This Service Letter reidentified as
Service Bulletin M 20-99
per Service Instruction M20-15.

SUBJECT: Inspection of Oil Radiator Flanges and
Modification of Oil Radiator Installation

MODELS AFFECTED: M20C, Serial Numbers 1940 through 2219

FIGURE 1

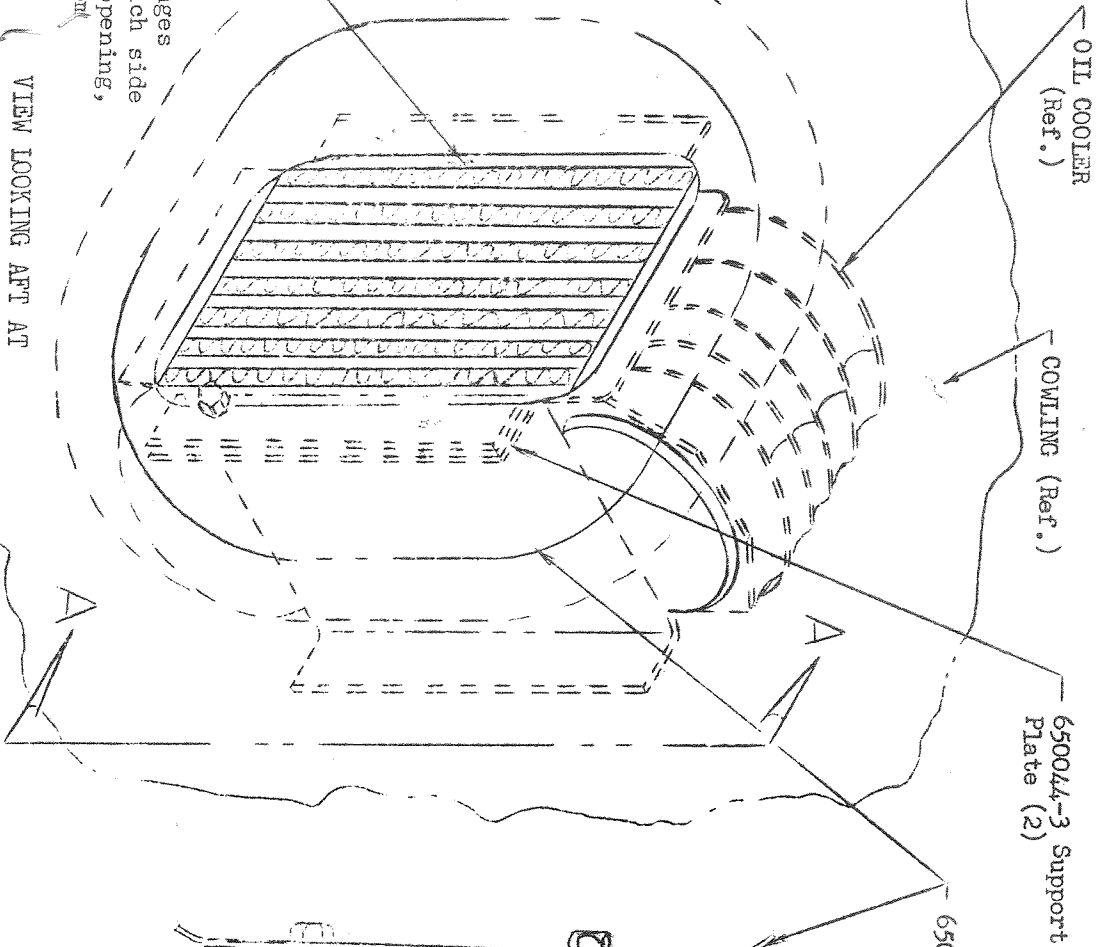
1. Inspect the oil cooler attachment flanges every twenty-five hours. The cracks are most likely to appear in the immediate area of the four mounting bolts and are clearly visible in the outside of the flange bend radii as shown in Figure 1.

Inspect flanges
for crack each side
of bracket opening,
top to bottom

FIGURE 2

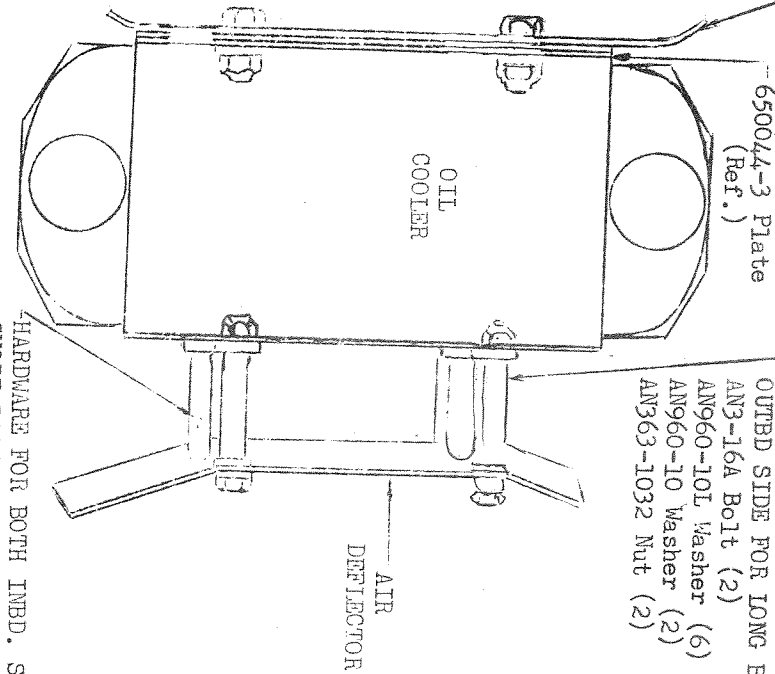
1. Remove the oil cooler from the mounting bracket.
2. Remove the air deflector from the back of the oil cooler.
3. Position the oil cooler on the mounting bracket and insert the bolts. If any of the bolts must be forced into place, this indicates the holes are misaligned and the holes should be reamed with a #12 drill. Forcing the bolts can cause the flanges to crack.
4. Install 650044-3 support plate as shown in Figure 2. Install the nuts and tighten.
5. Cut the two inboard air deflector bushings as shown in Figure 2. In some instances, the deflector may be installed with two bushings on each bolt. In this case, discard the shorter bushing and re-install the air deflector using only the 7/8" long bushings on the inboard side.

VIEW A-A
SHOWING INSTL OF
MODIFIED BUSHING
